Rezoning Transportation Analysis

Petition Number: 2018-067

Revision Log:

Date	Description
07-23-2018	First Review
08-21-2018	Second Review

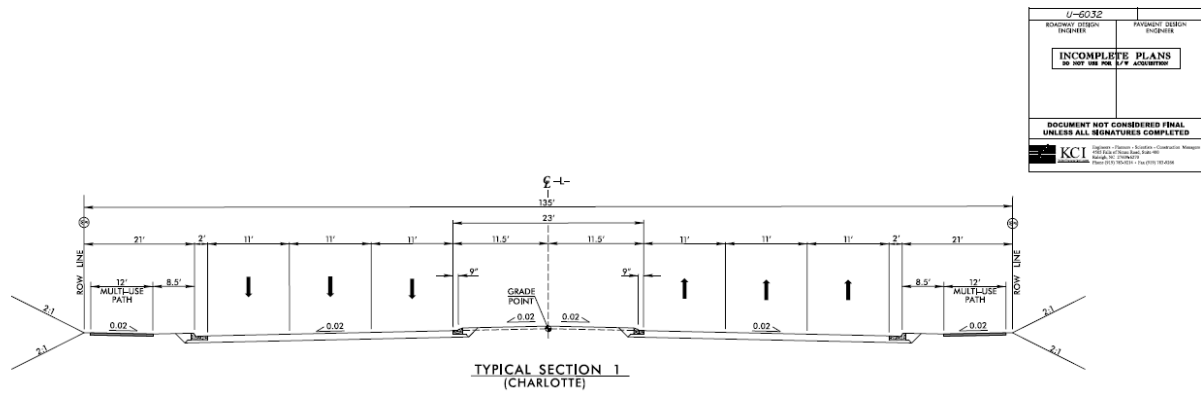
1. **Curbline** The proposed zoning district has a setback measured from back of the proposed future curbline. Mallard Creek Rd's future back of curb needs to be located (to be determined) as measured from Mallard Creek Rd.'s existing centerline (see below Typical Section). This dimension and call-out needs to be depicted on the revised site plan. With that said, NCDOT is in the process of revising the Mallard Creek Rd. centerline alignment. Most likely the proposed western curbline and right-of-way line will encroach further into the site. We need to have a meeting in a couple of weeks to discuss the NCDOT revised concept.
